**DR. JUDY WOOD**

September 14, 2008

Re: Comments

Set forth below are comments on the "**Final Report on the Collapse of World Trade Center Building 7 Draft for Public Comment**" dated August 21, 2008 (NCSTAR 1A). The source of the said NCSTAR 1, meaning the point at which it can be and has been accessed, is: <http://wtc.nist.gov/>

**Figure 1.**  
page 9-10 of 115 of pdf, (labeled page vii-viii of report) [http://wtc.nist.gov/media/NIST\\_NCSTAR\\_1A\\_for\\_public\\_comment.pdf](http://wtc.nist.gov/media/NIST_NCSTAR_1A_for_public_comment.pdf)

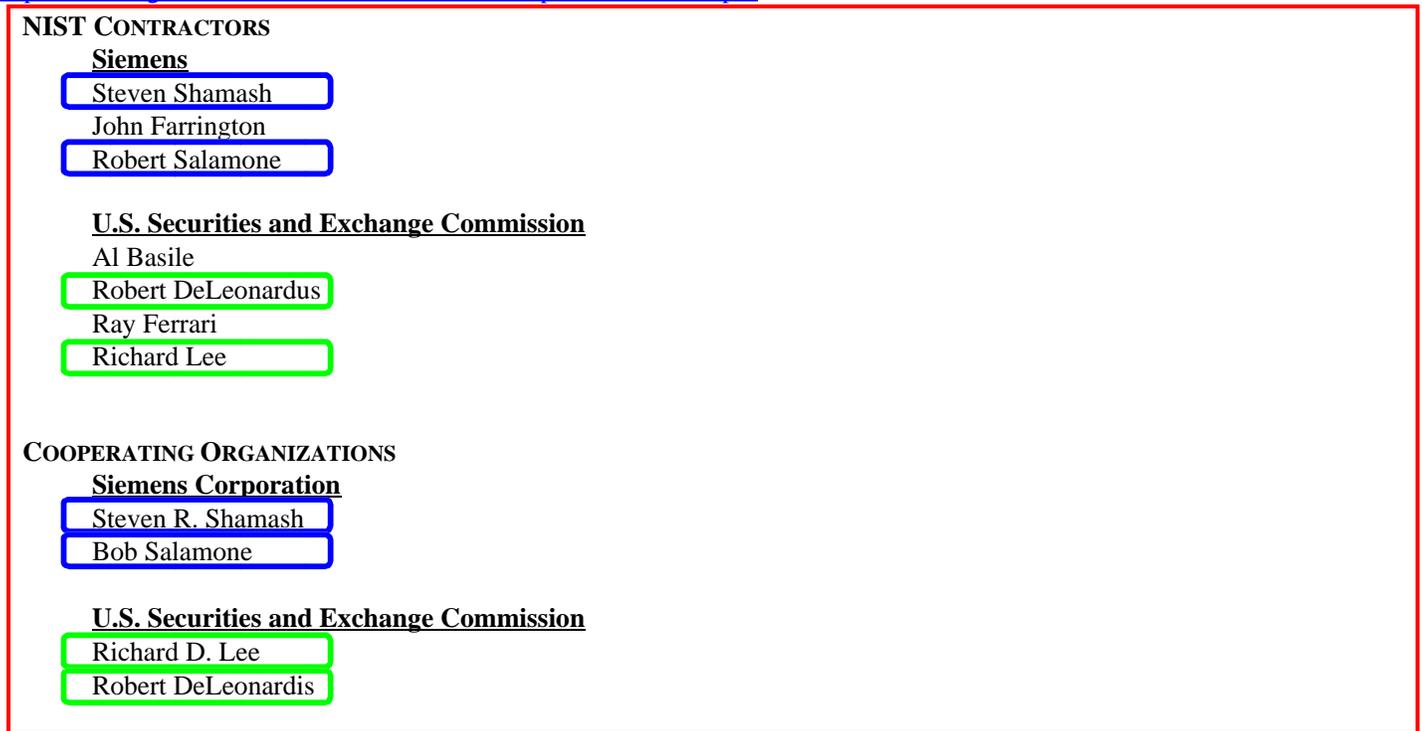
**Reason for Comment:** The listings are inconsistent with individuals being listed as paid contractors and cooperating organizations. This should be clarified. Mary Guida is listed twice (GSA is listed twice).

**Suggestion for Revision:** Delete or modify as necessary.

**Figure 1–5. Typical WTC 7 floor showing locations of the columns, girders, and beams..**

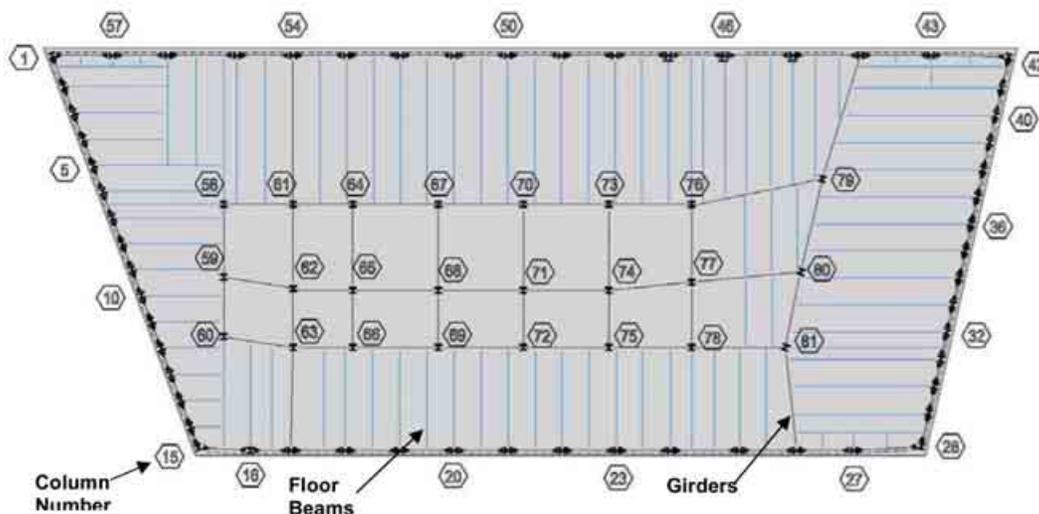
**Reason for Comment:** Building structure as given in the document(s) is incomplete – therefore the analysis is incomplete. Location of beams alone is insufficient to make a valid assessment. Much more structural information needs to be included, with more specific details of dimensions, weights and materials involved for anything which fell to the ground.

**Suggestion for Revision:** NIST has determined that the dimensions of the beams referenced here are as follows: [provide dimensions]

The aspect ratio of the dimensions provided in Table D1 are shown above.

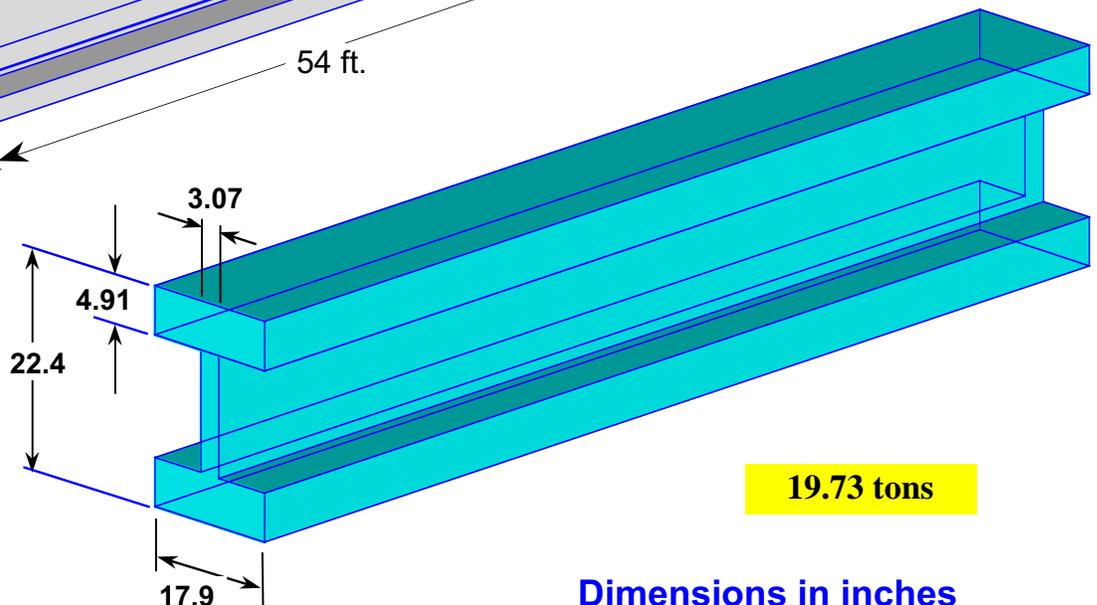
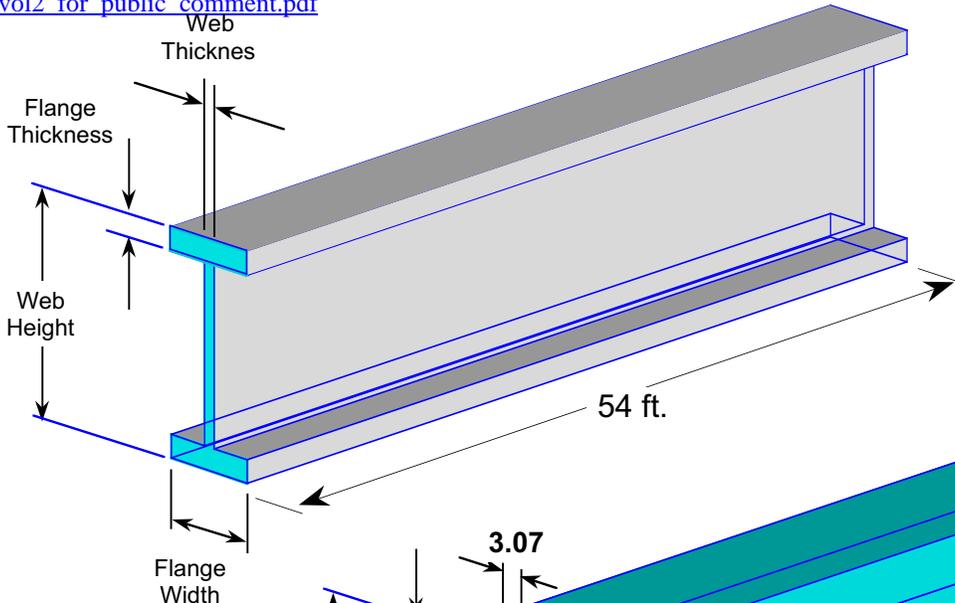
**Reason for Comment:** The aspect ratio of beam cross sections shown in the report do not have dimensions. The dimensions provided in the report describe beams with a very different aspect ratio. Dimensions and weights of beams used in this analysis must be provided so that the plausibility of NIST's theory can be properly assessed, among other things. Basically, we are led to believe that very large columns, beams and girders were all sufficiently heated by ordinary office fires that burned for no more than 20 minutes in any one area resulted in multiple, nearly simultaneous failure. That explanation is, of course, implausible, but, at a very minimum, accurate dimensions of what failed must be both provided in detail and properly diagrammed.

Because NCSTAR 1-A refers to collapsing beams, it is essential that the correct aspect ratio is depicted. Otherwise, a highly misleading report would be foisted on the public. We are already required to accept that a 47-story building could collapse in a matter of seconds. At a minimum, correct diagrams of what is said to have collapsed are required. If not, then the appearance of fraud is overwhelmingly confirmed.

This revision requires re-do of diagrams as exemplified above to show correct aspect ratios.

**Figure 2–2.** Eastward buckling of Column 79, viewed from the southeast.

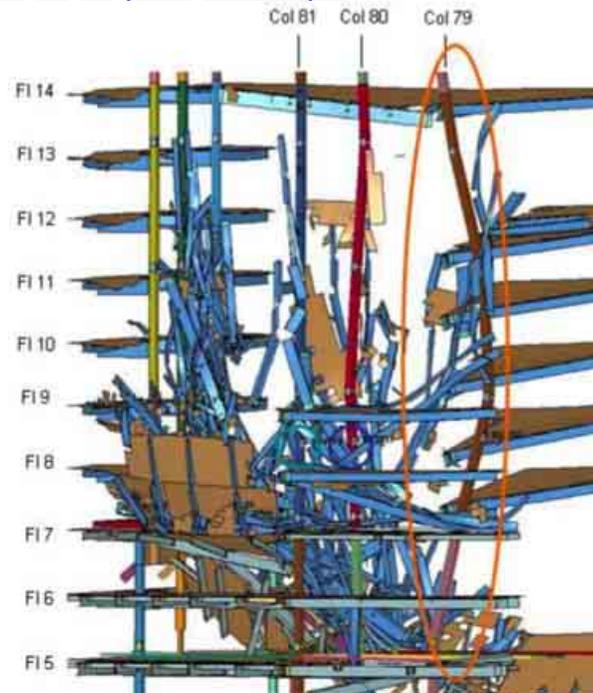
### Reason for Comment:

**Figure 86.**  
 page 56 of 170 of pdf (labeled page 4 of report),  
[http://wtc.nist.gov/media/NIST\\_NCSTAR\\_1-9A\\_for\\_public\\_comment.pdf](http://wtc.nist.gov/media/NIST_NCSTAR_1-9A_for_public_comment.pdf)

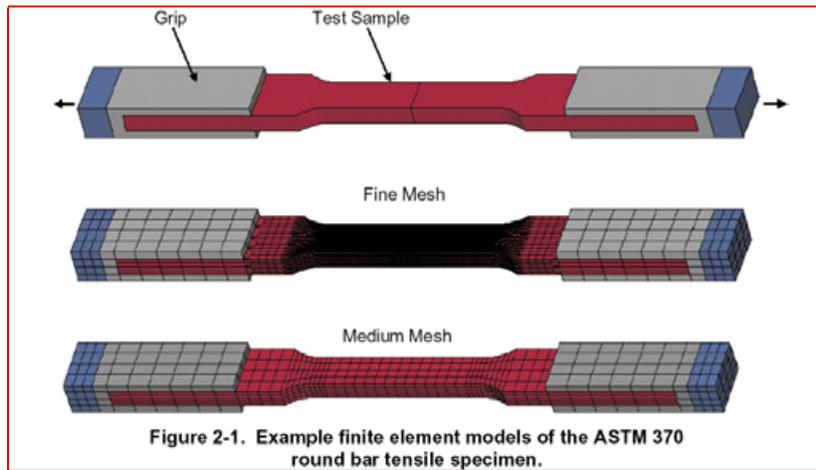
**Reason for Comment:** Figure caption is not consistent with the image shown. Figure 85 and the commentary describing it should be corrected to accurately describe the image shown.

**Figure 105.**  
page 160 of 170 of pdf (labeled page 108 of report),  
[http://wtc.nist.gov/media/NIST\\_NCSTAR\\_1-9A\\_for\\_public\\_comment.pdf](http://wtc.nist.gov/media/NIST_NCSTAR_1-9A_for_public_comment.pdf)

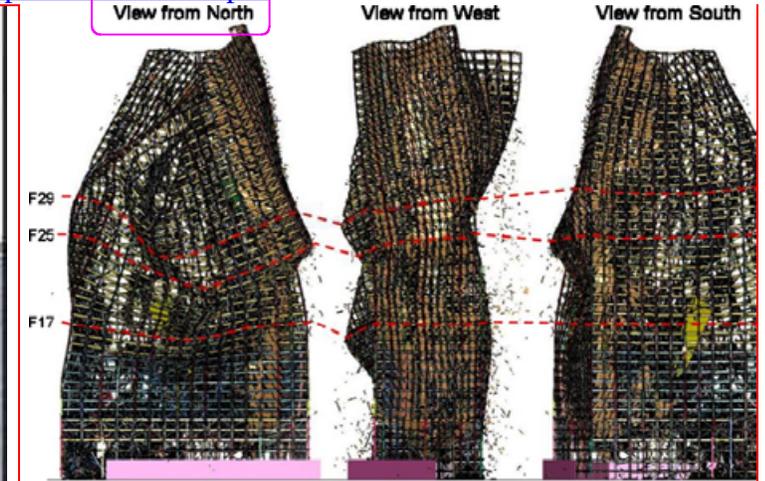
Modeling of the progressive/global collapse shows the building contorting, flexing and losing its shape. This is inconsistent with pictorial and video evidence. Observed evidence is the truth theory must mimic. The diagrams in Figure 105 do not mimic the real event, shown in Figure 104. The models presented are inadequate as explanations for the data/phenomena briefly outlined in parts of this document.
